Title of Change:	Update datasheet for adding the dependent on switching time characteristics and input pulse width.
Effective date:	15 December 2016
Contact information:	Contact your local ON Semiconductor Sales Office or <Osamu Akaki@onsemi.com>
Type of notification:	ON Semiconductor will consider this change accepted.
Change category:	☐ Wafer Fab Change ☐ Assembly Change ☐ Test Change ☒ Other Datasheet Update

This Product Bulletin updates the datasheet in order to add characteristics suitable for the customer's application use.

Fig.1 Switching Time Test Circuit 1

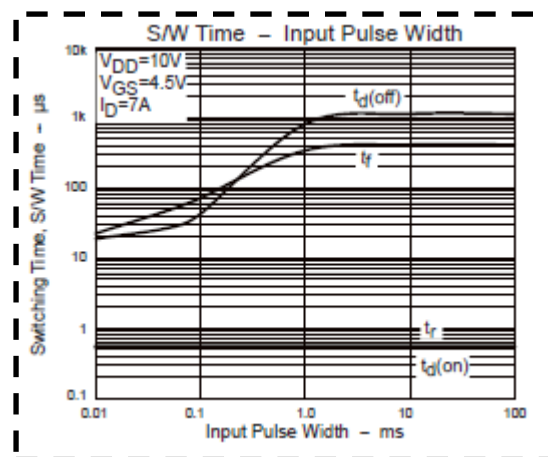
- 1) Switching time $PW > 10ms$ value. (Page.2)
- 2) Switching time circuit of $PW > 10ms$. (Page.2)
- 3) Note 3 : The fall switching time is dependent on the input pulse width. (Page.2)
- 4) Dependency graph of switching time and input pulse width. (Page.3)

Turn-ON Delay Time	$t_{d(on)}$	See Fig. 1 (Note 3)	545	ns
Rise Time	t_r		525	ns
Turn-OFF Delay Time	$t_{d(off)}$		18.65	μs
Fall Time	t_f	See Fig. 2 (Note 3)	22.2	μs
Turn-ON Delay Time	$t_{d(on)}$		545	ns
Rise Time	t_r		525	ns
Turn-OFF Delay Time	$t_{d(off)}$		1,130	μs
Fall Time	t_f		410	μs
Total Gate Charge	Q_g		13	nC
Gate to Source Charge	Q_{gs}	$V_{DS} = 10V, V_{GS} = 4.5V, I_D = 14A$	3	nC
Gate to Drain "Miller" Charge	Q_{gd}		2.4	nC
Forward Diode Voltage	V_{SD}		0.78	1.2 V

Note 3 : The fall switching time is dependent on the input pulse width.
